**Development Review Committee
September 20, 2023
Council Chambers
2:00 PM**

**SPR (2022)-0014, 601 Trelago Way
Maitland Concourse North Lot 1 (SPR)
DRC DECISION**

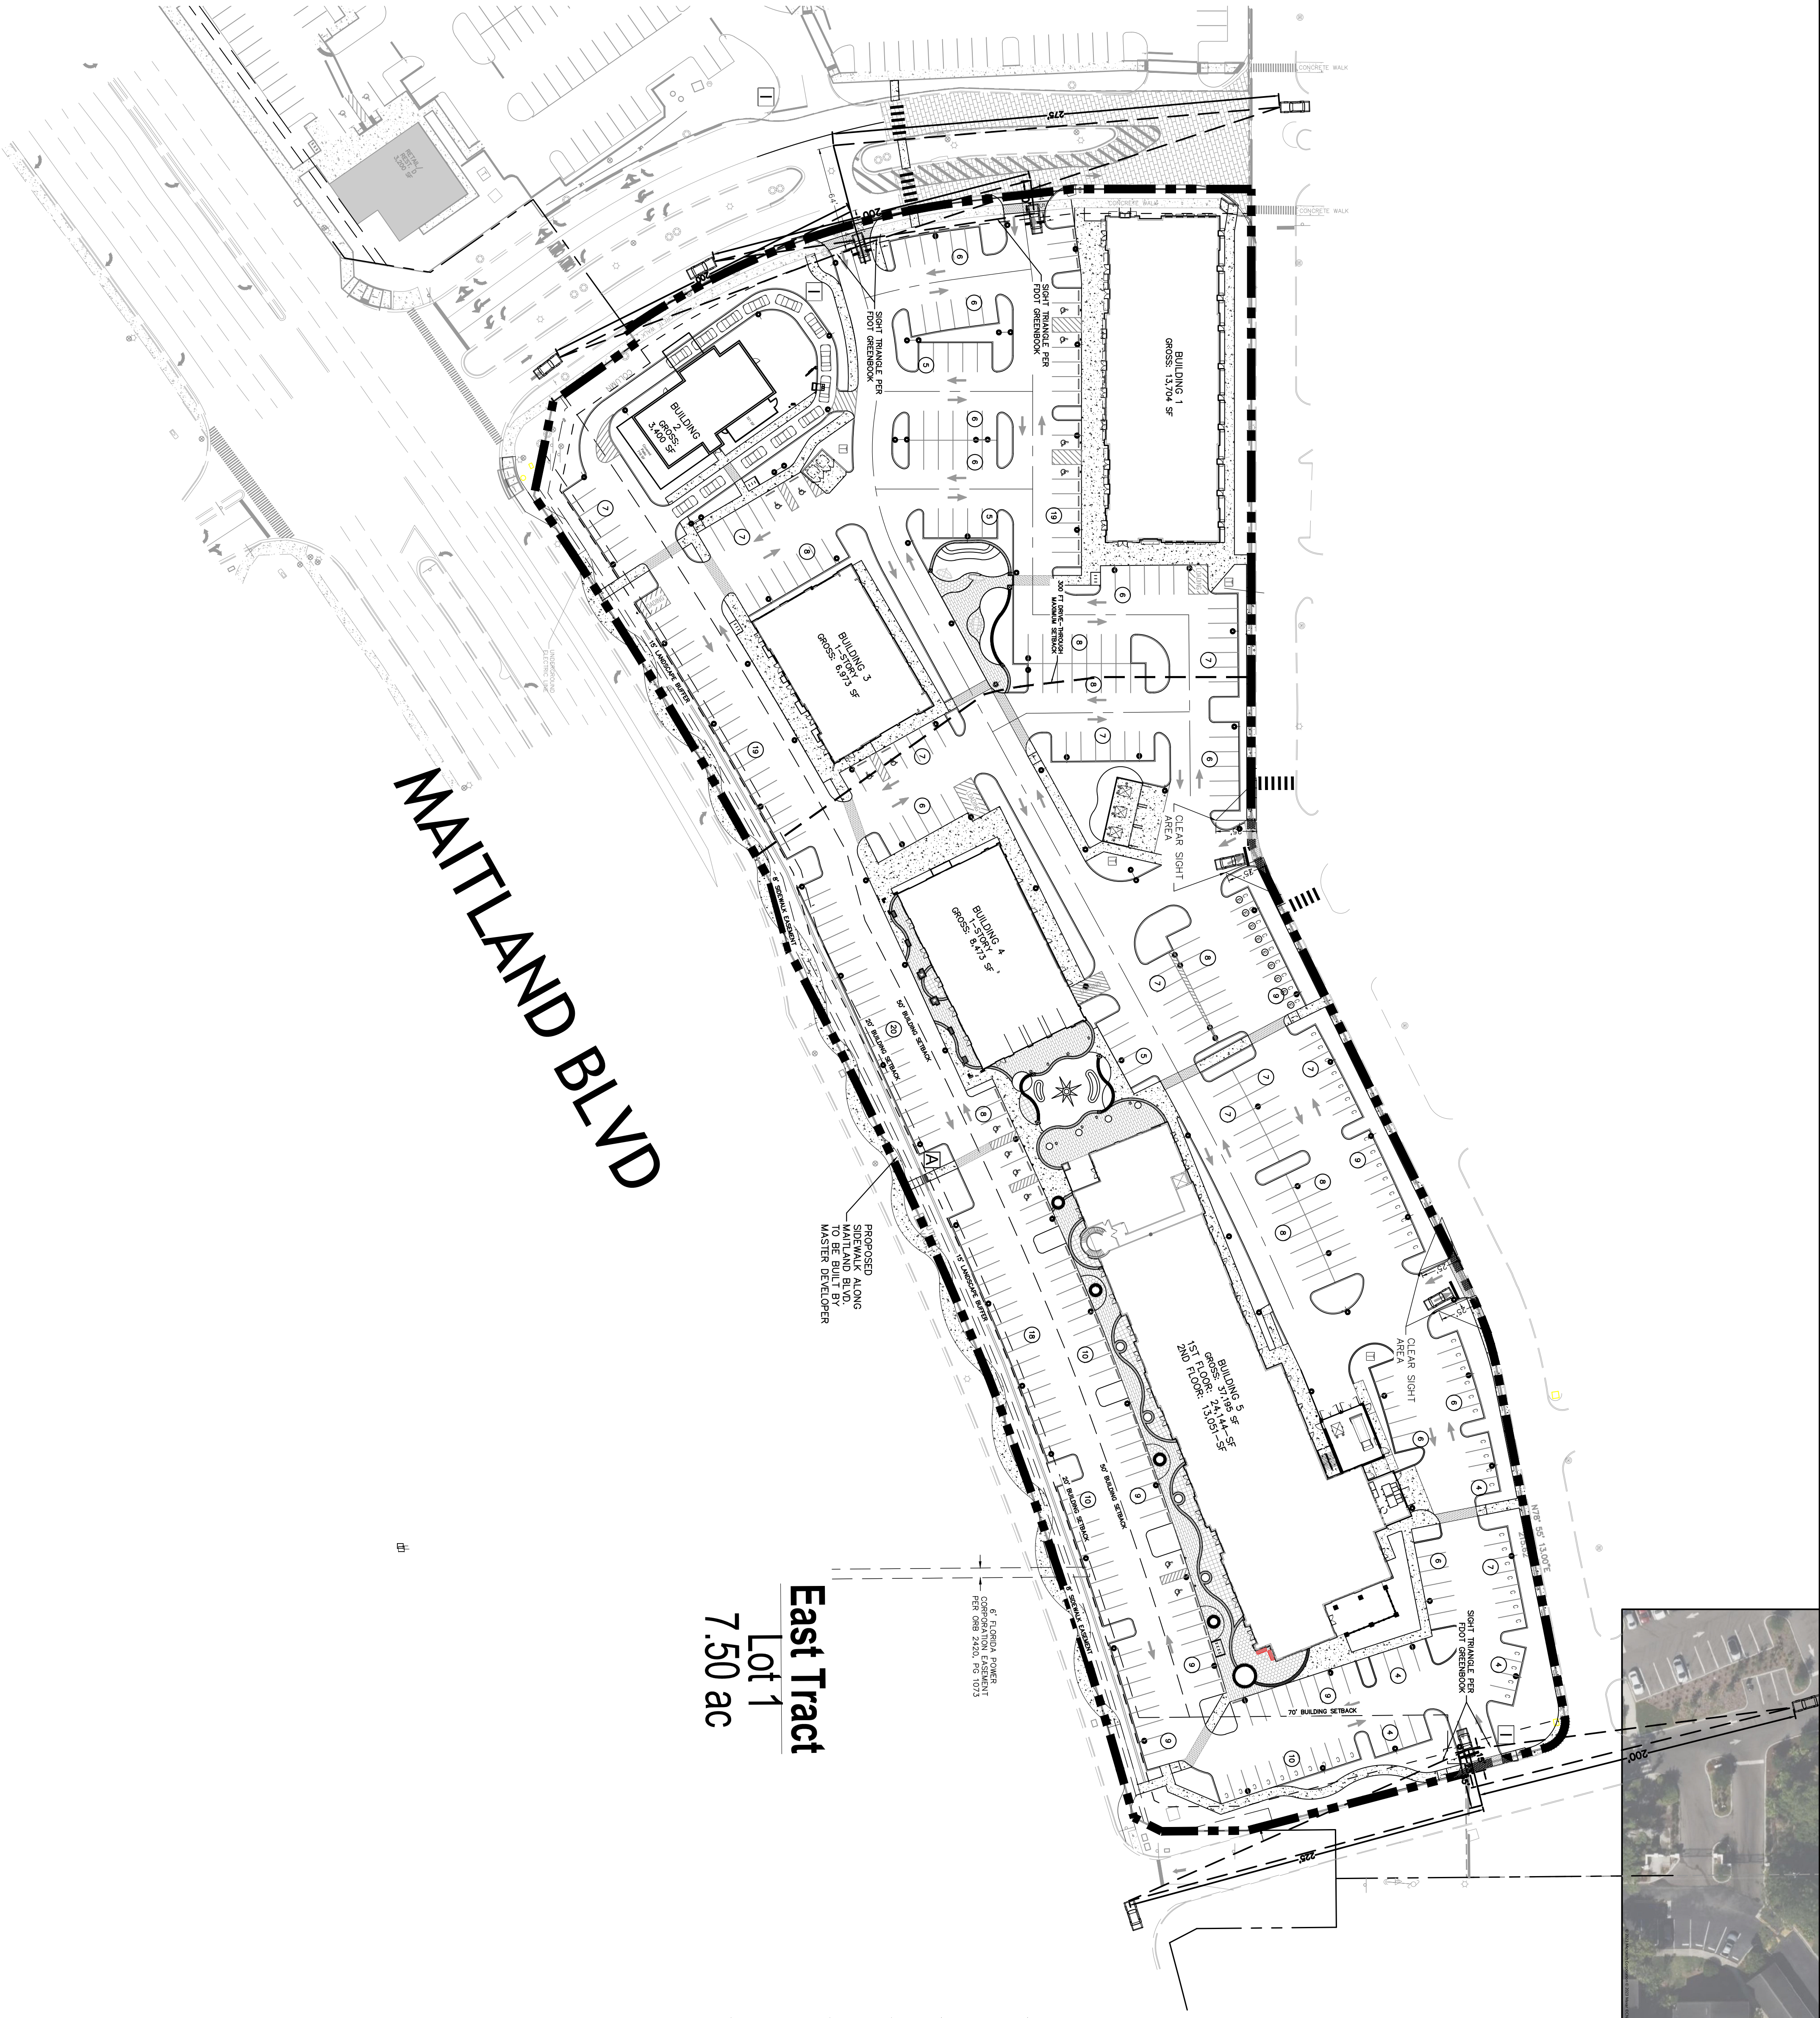
45. Revisions: C6.2, Utility Plan, the irrigation meter as proposed would be private. Please acknowledge. **New submittal removed the location of the irrigation meter, while note does address private/public—the location still needs to be shown. Provide irrigation meter. Comment Not Addressed. 7/5/23.** Provide a callout for the valve after the tee for the proposed 1 ½” irrigation connection. In addition, new callouts were added to the planset that was not rev clouded or mentioned in the comment response. There is reference to a reuse connection. The City does not have reuse. Who owns this reuse line? Does the 3” line exist today or is that incorrectly labeled? **Comment Not Addressed. 8/24/23**

49. L1.00, overall Landscape plan, show all the sight triangles. Sight triangles do not meet sight distance requirements for stoppage. **Comment Not Addressed. 7/5/23** While sight triangles are added, landscaping and trees are still located within this area. Please confirm landscaping will be the right type for the right place. **Comment Not Addressed. 8/24/23**

51. L4.00, Lighting plan, show the proposed lights on the site plan to ensure there are no conflicts with other improvements. **Light poles were added to the landscape plan, but also need to be on the site plans as poles could also conflict with site features, storm, and utilities. Sheet L1.01 – Light pole in parking island on the far east side along the matchline north of the compass rose appears to be surrounded by trees. Revise accordingly. Sheet L1.01 – Light pole in parking island north of Building 3 has a Date Palm that appears to be in conflict. Revise accordingly. Comment Not Addressed. 7/5/23** At the SW corner of building 2 a light pole is shown directly over the storm line. There is no detail for the light pole base, so conflict may arise. The solid waste container north of building 4 has a light pole that could conflict with the loading operation of the trucks. The loading area for building 4 shows a light pole in the middle of the loading zone that should be shifted outside of the loading zone. Please ensure all conflicts are checked and resolved. **Comment Not Addressed. 8/24/23**

74. Streetlights/parking lights should be shown on the landscape plan. Please provide. **See comment 51 for conflicts. Comment Not Addressed. 7/5/23** Light poles symbols throughout the planset and landscaping set have items that show them within the road or parking stalls. Please ensure accuracy. **Comment Not Addressed. 8/24/23**

76. Streetlights/parking lights should be shown on the landscape plan. Please provide. **See comment 51 for conflicts. Comment Not Addressed. 7/5/23** Light poles symbols throughout the planset and landscaping set have items that show them within the road or parking stalls. Please ensure accuracy. **Comment Not Addressed. 8/24/23**

92. There is a 90-degree bend called out in front of Building 1 that shows a 3rd line leaving the bend that serves the western 3 water service connections. How does this 3rd line connect at the tee and what size line is proposed? Utility connections to Building 1 have been redesigned. On the east end near the hydrant there is a 2" water service that does not seem to serve anything. What is this for? The revision to the potable connections for building 1 have resulted in a dead end of the watermain. This would require a 2-inch blow-off at the end of the watermain. Comment Not Addressed 7/5/23 Sanitary manhole S-8 was added with the revision of the utilities for bldg. 1. There is no fall between the NW invert in and the SE invert out of manhole S-8. Revise the connections accordingly. Comment Not Addressed. 8/24/23

107. Provide sight triangles on site plan and landscape plan for all access points. The Sight triangles do not meet the FDOT design criteria. Comment Not Addressed. 7/5/23 Sight triangles have been added but there are several trees located within the area. Please confirm right tree/landscaping right place. Comment not addressed 8/24/23
